Lodgement Number: LDG-057707-22 Case Number: ABP-314485-22

PA Reg Ref: **F20A/0668**

Observation on a Planning Appeal: Form.

3.	During the appeal process we will post information and items to you or to your agent. For this observation, who shou ldwe write to? (Please tick ✓ one box only.)		
	You (the observer) at the address in Part 1 in Part 2		
eta	is about the proposed development		
4.	Please provide details about the appeal you wish to make an observation		
	on. If you want, you can include a copy of the planning authority's decision as the observation details.		
(a)	Planning authority (for example: Ballytown City Council)		
(b)	(for example: ABP-300000-19)		
(c)	PL06F.314485 Planning authority register reference number (for example: 18/0123) F20A/0668		
(d)	Location of proposed development (for example: 1 Main Street, Baile Fearainn, Co Abhaile) Dublin Airport, Co Dublin

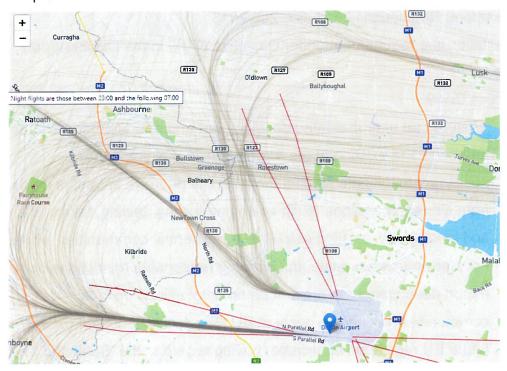
- Flying divergent flight paths on the No rth Runway for Westerly operations contravening the EIS of 2007
- Divergent flight paths currently in operation do not align with EIAR for this current plann irg application that is under appeal
- 30-degree divergence was not proposed in the 2016 consultation
- Condition 3 of planning does not allow for dual r unway departures under Option
 7b
- Flight paths used in Insulation Scheme approved by Fingal County Council in
 2016, based on 2007 planning pe mission, show straight out operations

Departures on North Runway on August 25-27th and all dates of westerly departures since opening are showing divergent routes contravening the planning permission from 2007
